ADDENDUM NO. 1

State of Maine Ray Building Renovation
28 Tyson Drive
Augusta, ME

April 13, 2022

From: Wood
Environment & Infrastructure Solutions
511 Congress Street
Portland, Maine 04101

SHEET ID:
AE521

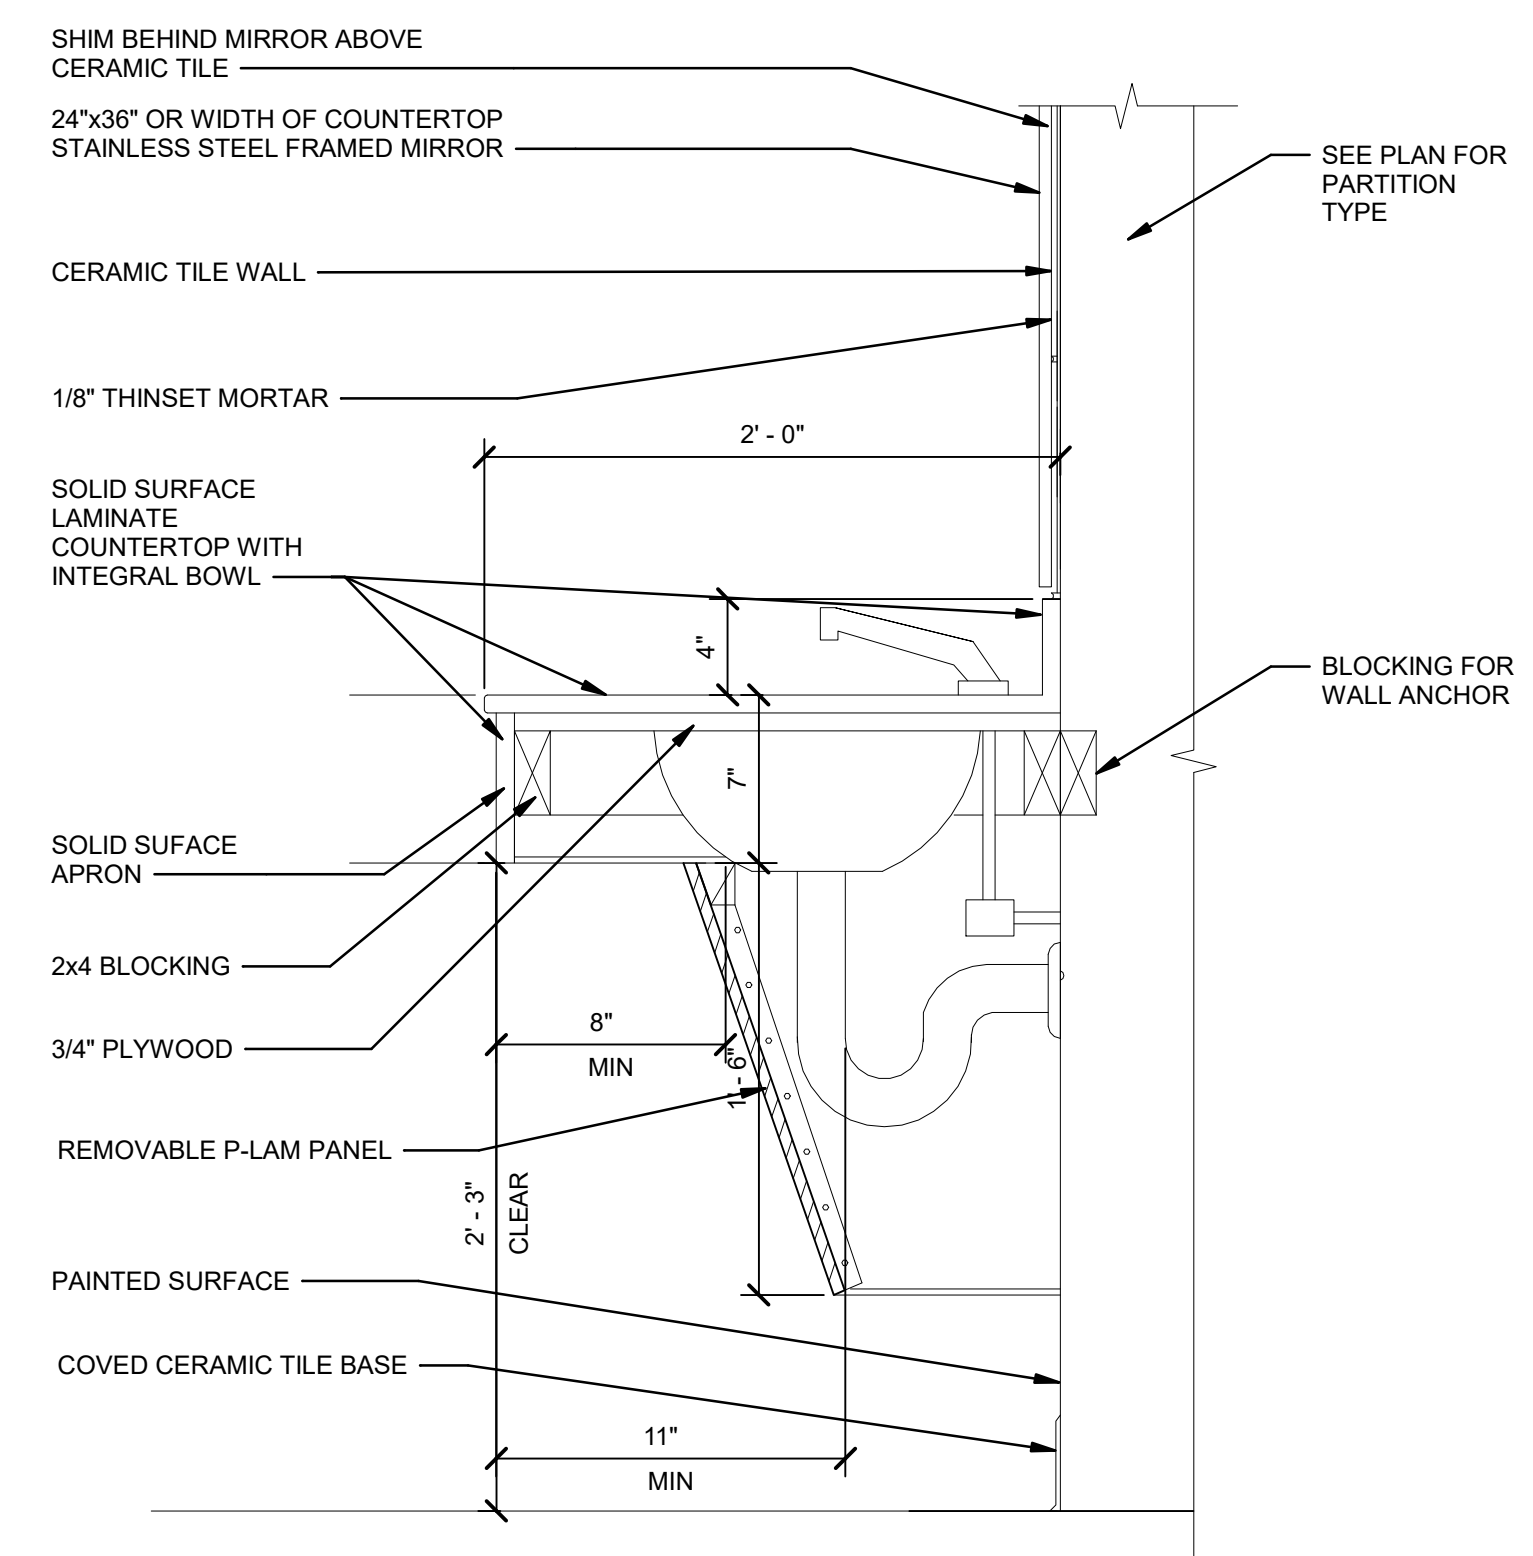
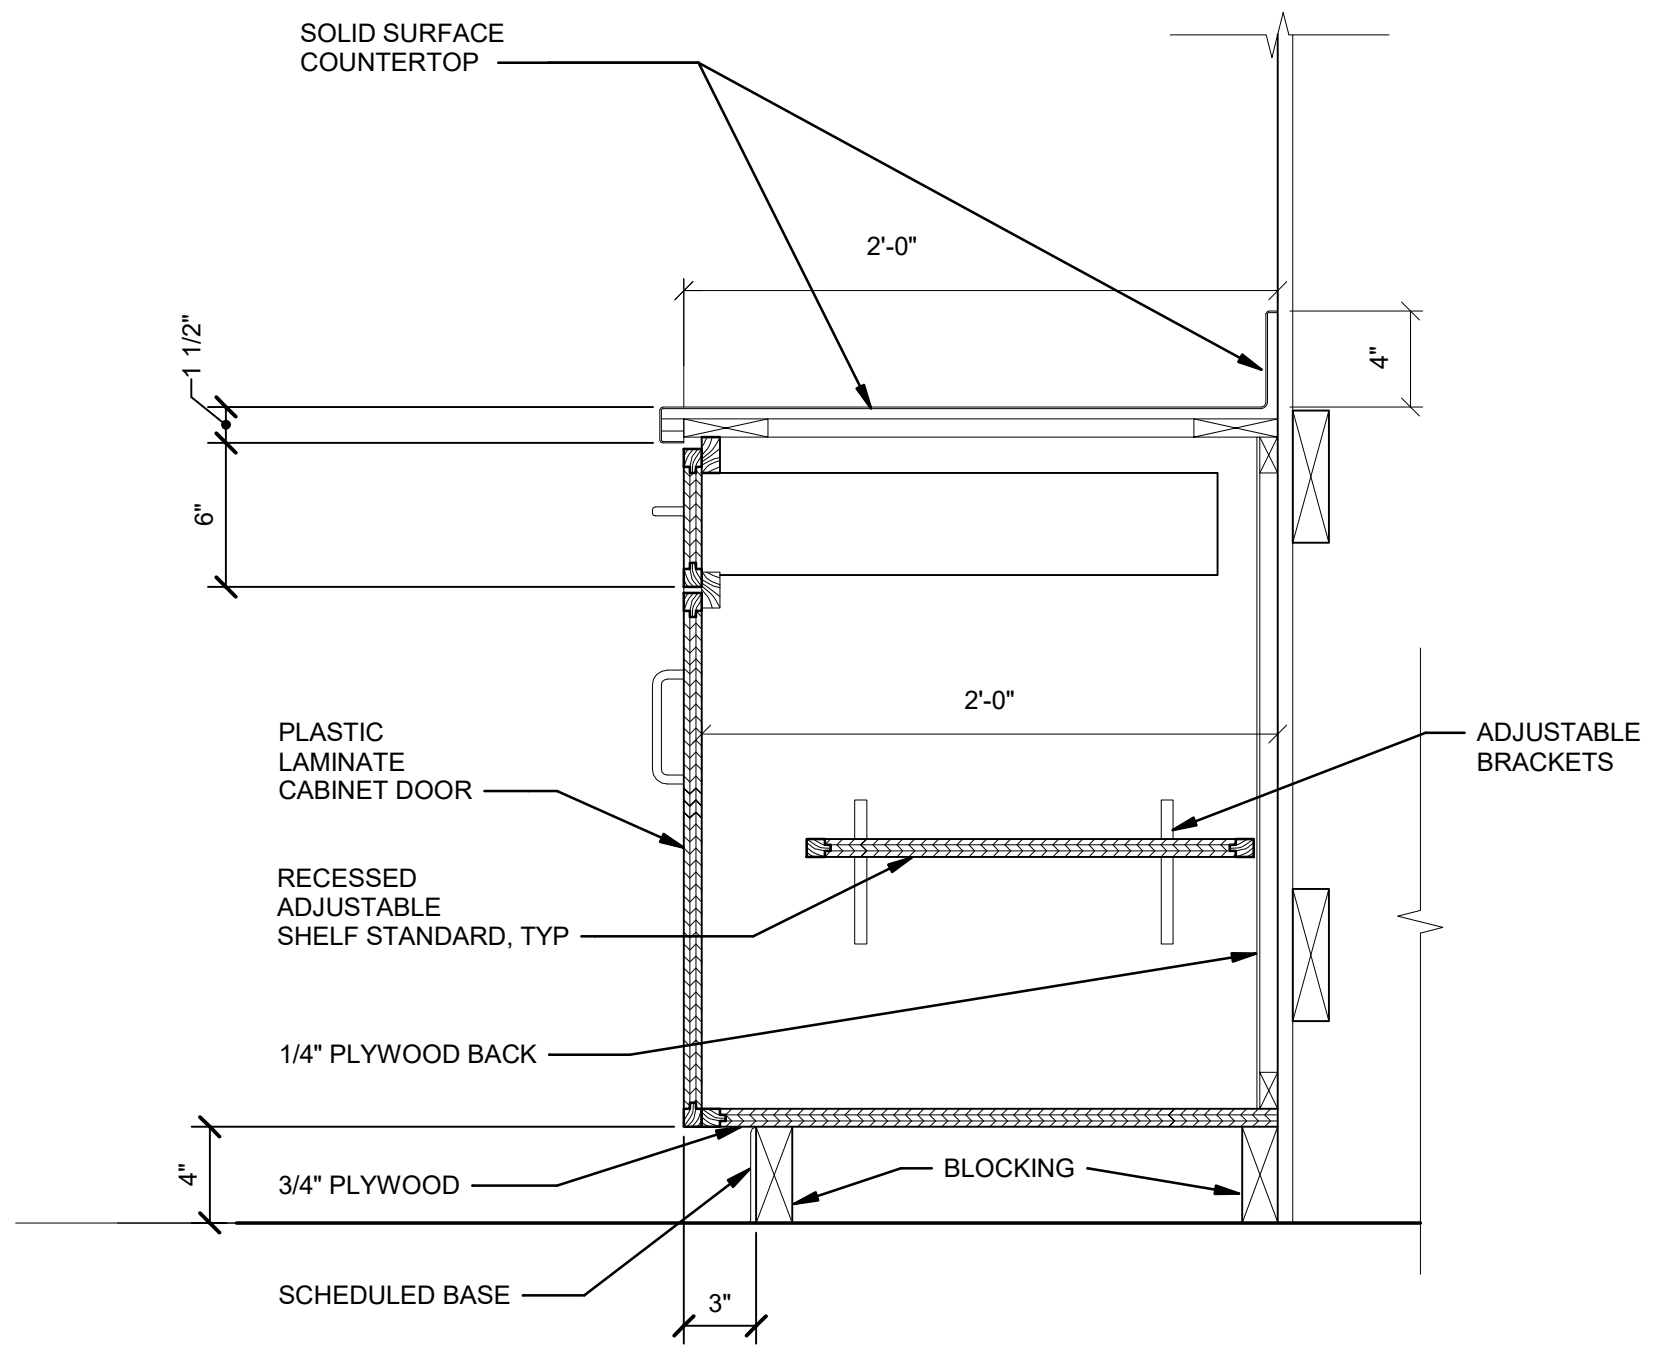
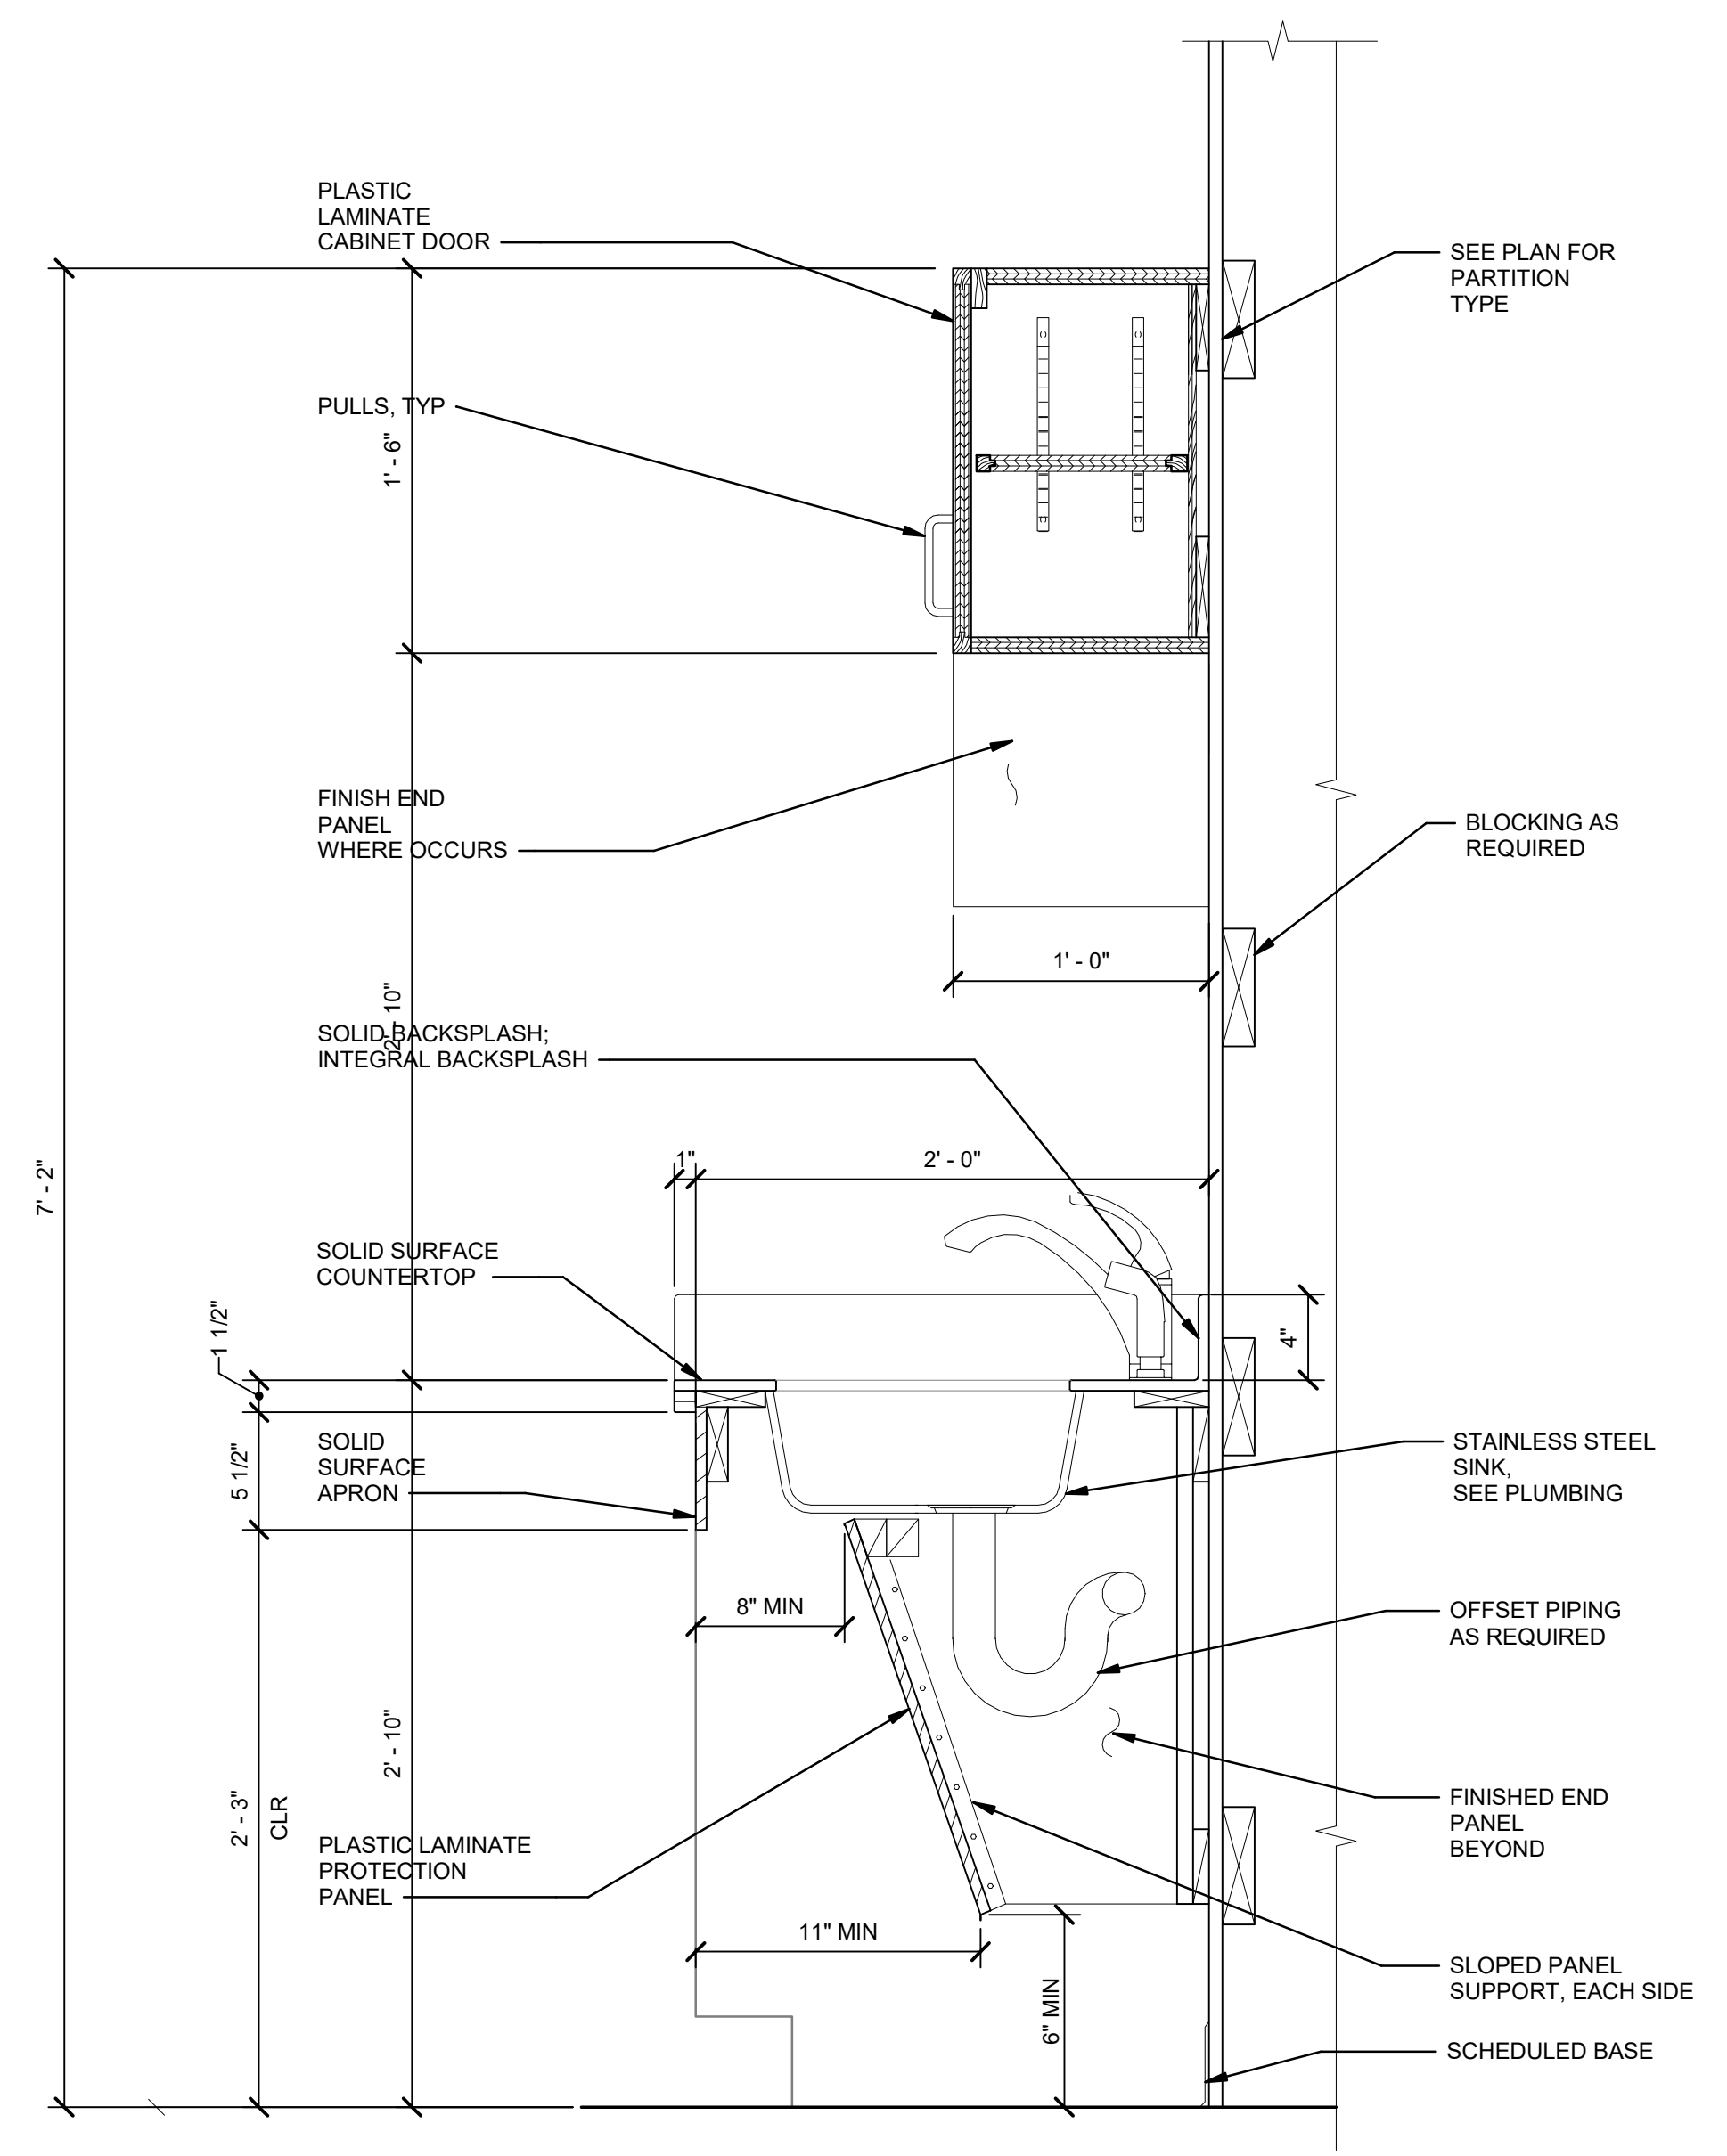
1. REPLACE drawing AE521 with the attached revision dated 04-13-2022. Soffit was removed from around the coiling door hood per RFI#
